RECEIPT DATE: 07/09/2021 **ONSITE SEWAGE DISPOSAL SYSTEM** P 569597
 APPROVAL DATE: 1/26/2022 **PERMIT: CONSTRUCTION** A _____
 PROPERTY ADDRESS: 6521 MARE COURT, DAYTON, MD 21036
 SUBDIVISION: WILLOWSHIRE LOT: 9 TAX ID: 03-602997
 CONTRACTOR: CHAVIS ENTERPRISES & SEPTIC SERVICES EMAIL: Ryan@chavisenterprisesllc.com
 CONTRACTOR ADDRESS: 23 EAST ELLENDALE, BEL AIR, MD 21014 PHONE: (410)838-3007
 PROPERTY OWNER: TOLL MID-ATLANTIC LP COMPANY, INC EMAIL: Sriley1@tollbrothers.com
 OWNER ADDRESS: 250 GIBRALTER ROAD, HORSHAM, PA 19044 PHONE: (410)872-9165
 SEPTIC TANK SIZE (GALLONS): 2000 TANK MANUFACTURER: Back River Pre-Cast, LLC
 PUMP MODEL: ME3H-11P PUMP SIZE 0.3 Hp PUMP TANK CAPACITY: 2000

APPROVED SEPTIC SYSTEM PLAN
Howard County Health Department
2000-gal Septic Tank
w/ 2000-gal Pump Tank
& Myers ME3 Series pump
Signature: [Signature]
Date: 5/26/2021
Gravity Distribution
for 6-Bedroom Residence

ONSITE SEWAGE DISPOSAL SYSTEM DESIGN PLAN
LOT 9 WILLOWSHIRE
LIBER 18-479, FOLIO 296
PLAT NO. 25503
ELECTION DISTRICT NO. 5
HOWARD COUNTY, MARYLAND
ADDRESS: 6521 MARE COURT
DAYTON, MARYLAND 21036

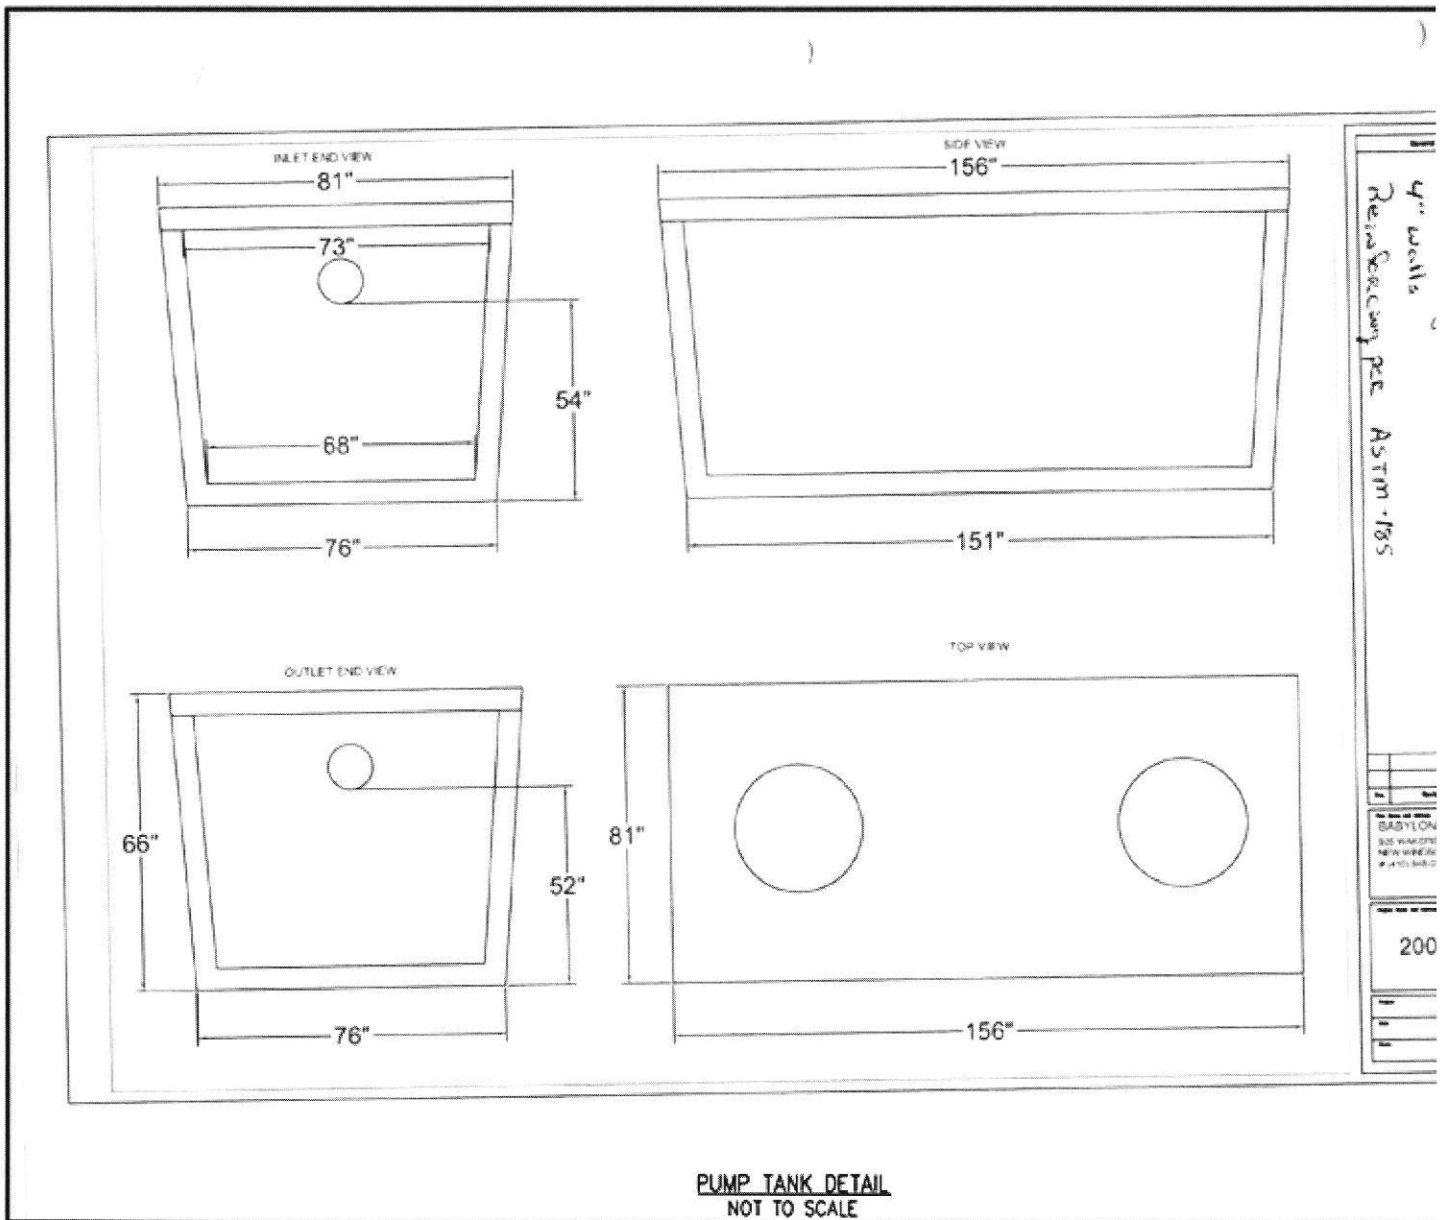
Please see the below request from the PM for the Willowshire project. Can they use a non-traffic bearing tank instead of the tanks shown? These took awhile to get approved as it is, please let us know if they can make that change without a revision or if a revision is needed etc.

Afternoon gents, All three of these lots show the Pump Tank Detail as Traffic Bearing(see attached OSDs and below screenshot). Can we please get verbal approval to use non-Traffic Bearing pump tanks and submit for revision? We have the standard materials and equipment on site and would like to proceed with the installs tomorrow.

I am fine with you red lining the plan for this.

Hello Mike,
We could require a revision of these plans, but we would rather red-line an edit.
Do I have your permission to 'X' the Traffic-Bearing label and to write 'Not Traffic-bearing' next to it?
Robert Bricker, REHS/RS, L.E.H.S.
